Grid Code Modification Proposal Form																
<p>GC0184:</p> <p>Revising Minimum Reactive Capability Requirements within European Connection Conditions, ECC.6.3</p> <p>Overview: Reviewing the European Connection Conditions ECC.6.3 minimum reactive capability requirements to ensure they reflect the needs of the system now and in the future.</p>	<p>Modification process & timetable</p>

Figure 1 – Proposed Requirement for ECC.6.3.2.4

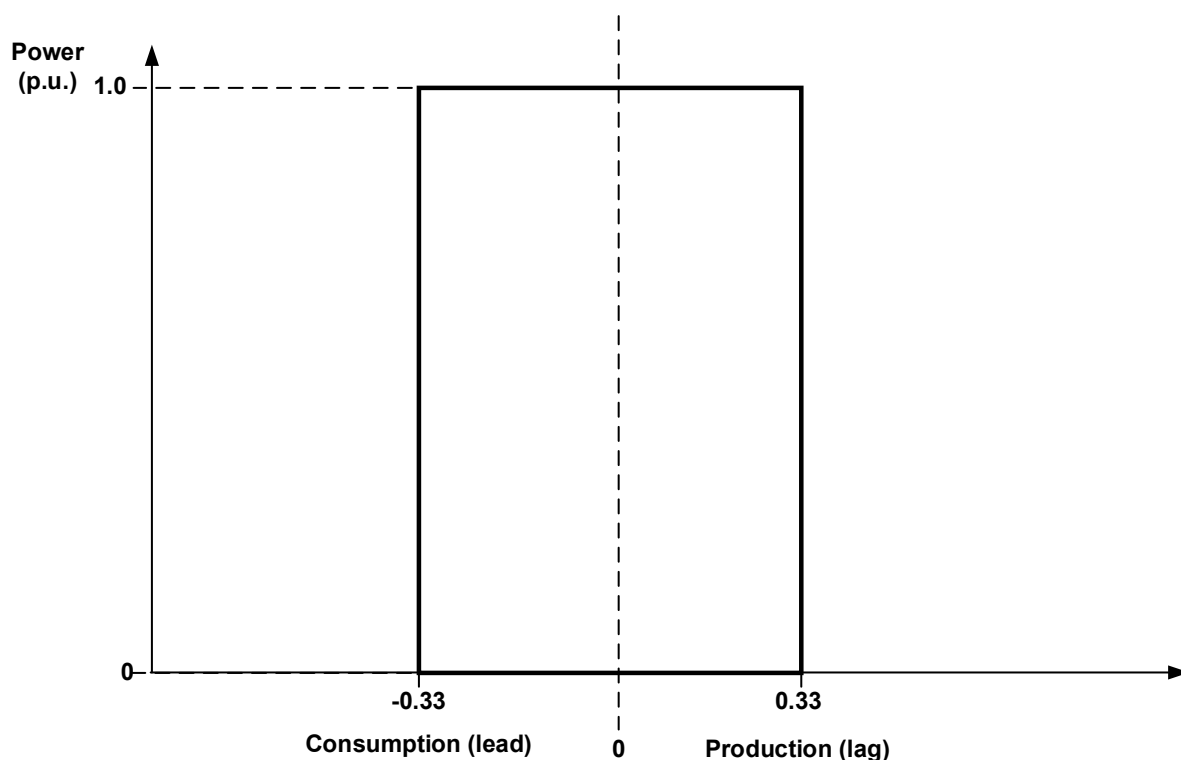
Plant or need for additional Plant, and consideration would be given to specific technology limitations. This would include an update to Grid Code clause ECC.6.3.2.4, which details the reactive power requirements for Type C and D Power Park Modules, High Voltage Direct Current (HVDC) Equipment and Offshore Transmission System Development User Works (OTSDUW) Plant and Apparatus at the Interface Point; Figure 1 outlines our recommendation for this. The solution would also remove the current option in ECC.6.3.2.4.4 where a reactive import capability between 50% and 20% of Maximum Capacity can be specified in the Bilateral Agreement. Appropriate amendments to other clauses would need consideration within Workgroup.
